**Crown Castle's Response to Audit Report for  
CA2025-1341 CIP Audit of Crown Castle's Riverside County  
October 22, 2025**

**CROWN CASTLE'S RESPONSES TO THE AUDIT REPORT'S RECORDS FINDINGS**

**Exhibit 1**

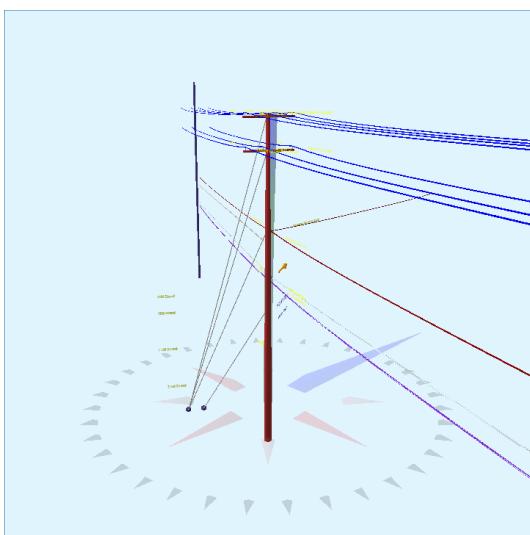
**ESRB staff observed that loading calculations by Crown Castle Communication for Pole 4207066E was missing two SCE down guys at heights of 55.5 ft. and 36 ft.**

Crown Castle respectfully disagrees with this finding. After investigation, Crown Castle has determined that the two Southern California Edison (“SCE”) down guy wires were not present at the time Crown Castle preformed the pole loading calculation provided in response to the pre-audit data request (April 26, 2021). SCE presumably installed the down guy wires at some point between April 26, 2021 and the date of the field visit. Out of an abundance of caution, on October 10, 2025, Crown Castle prepared a new pole loading calculation (“PLC”) that reflects the present state of the pole, its attachments, and support structures. The PLC demonstrates that the safety factor is well in line with the requirements of General Order (“GO”) 95, Rule 44.2. Please see Exhibit 1.

**Exhibit 2**

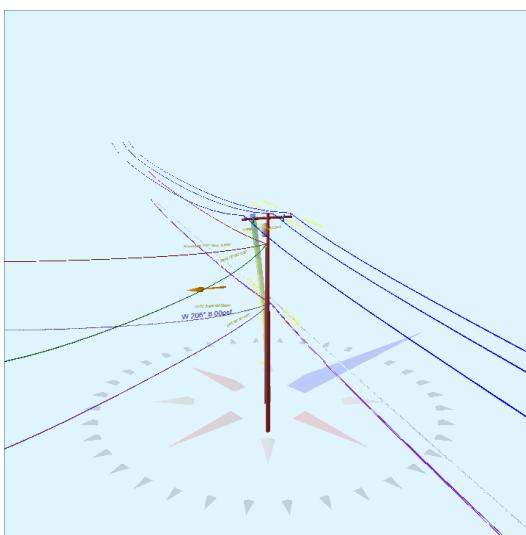
**ESRB staff observed that loading calculations by Crown Castle Communication for Pole 1667852E was missing a SCE secondary service drop at a height of 28 ft.**

Crown Castle acknowledges that the PLC it performed on April 28, 2021, which it provided in response to the pre-audit data request, inadvertently failed to reflect the SCE secondary service drop cable attached at a height of 28 feet. On October 10, 2025, Crown Castle prepared a new PLC that reflects the present state of the pole and its attachments. The PLC demonstrates that the safety factor is well in line with the requirements of GO 95, Rule 44.2. Please see Exhibit 2.

**Exhibit 3**

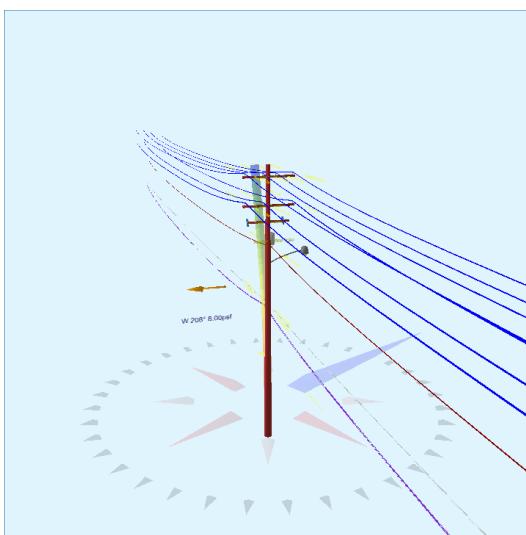
**ESRB staff observed during inspection that Pole 4207506E was a composite pole; however, the pole load calculation provided by Crown Castle Communication lists the pole species as Douglas Fir, thus, the pole load calculation are not accurate.**

Crown Castle respectfully disagrees with this finding. After investigation, Crown Castle has determined that, at the time it prepared the PLC provided in response to the pre-audit data request

(April 26, 2021), Pole 4207506E was a Douglas Fir. SCE presumably replaced the wood pole with a composite pole at some point between April 26, 2021 and the date of the field visit. On October 10, 2025, Crown Castle prepared a new PLC that reflects the present type of pole. The PLC demonstrates that the safety factor is well in line with the requirements of GO 95, Rule 44.2. Please see Exhibit 3.
